CERTIFICATE OF APPROPRIATENESS**Application Date:** April 23, 2025**Applicant:** Pawel T. Czekaj, agent for owners, Mrs. Heinrich- Savitz & Mr. Savitz**Property:** Lot 1, Block 8, River Oaks Country Club Estate Subdivision. The property includes an historic 6,751 sq. ft., three-story, with finished attic, brick veneer single-family residence and attached garage situated on a 22,626 sq. ft. (180 ft. x 127 ft.) corner lot.**Significance:** The D.W. Hovey House is a City of Houston Landmark designated by HAHC in May 2012. The D.W. Hovey House was designed and built by Alfred and Ivan Greer as a speculative house in 1937. The Greers designed and built numerous houses in River Oaks. The D.W. Hovey House was designed in the Colonial Revival style.
Addition done in 1999 and renovations in 2015**Proposal:** Remove all windows and several rear doors. Front door to remain.

CERTIFICATE OF APPROPRIATENESS**PLANNING &
DEVELOPMENT
DEPARTMENT**

Historic Window Standard: New Construction & Replacement

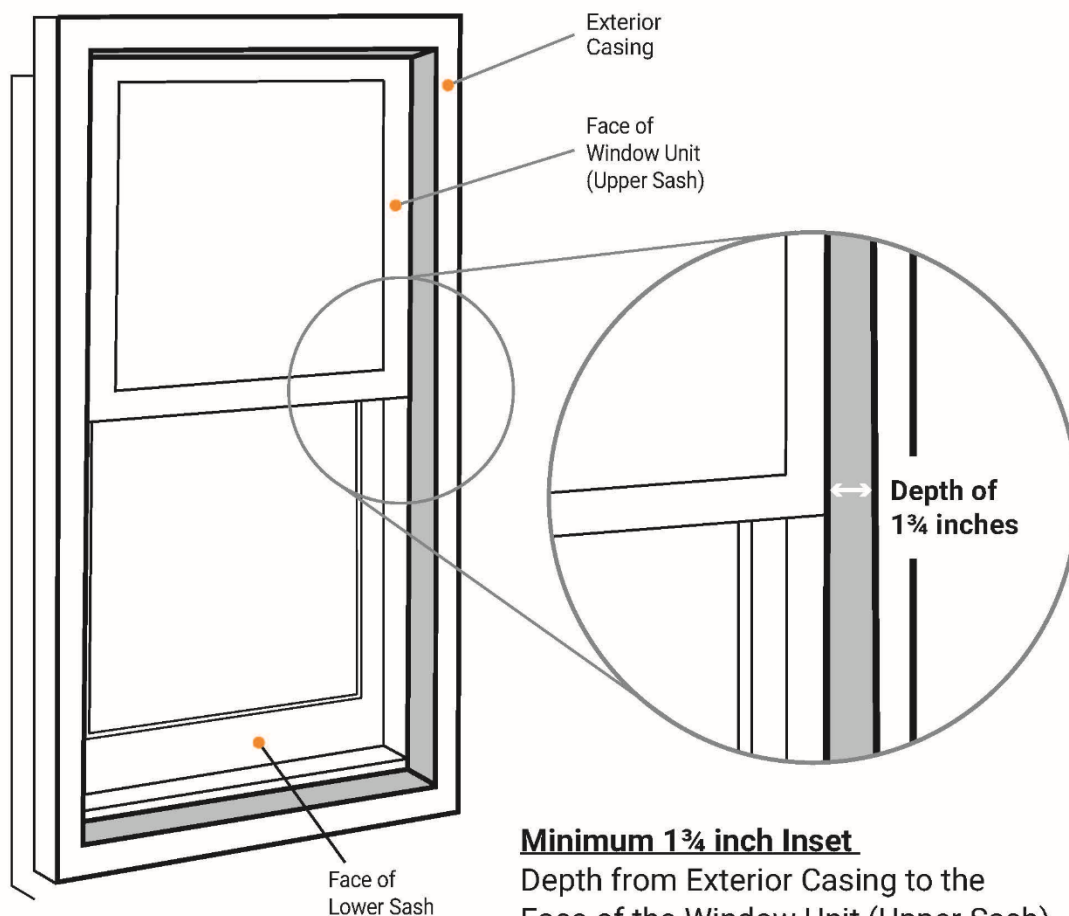
Public Comment: No public comment received.**Civic Association:** No comment received.**ALL NEW WINDOWS MUST BE INSET 1¾ Inches – See Attachment****Recommendation:** Approval**HAHC Action:** -

Minimum 1 3/4 inch Inset

Depth from Exterior Casing to the Face of the Window Unit (Upper Sash)

Windows must be 1-over-1
(equally horizontally divided)

1 3/4 inch minimum inset for Fixed Window
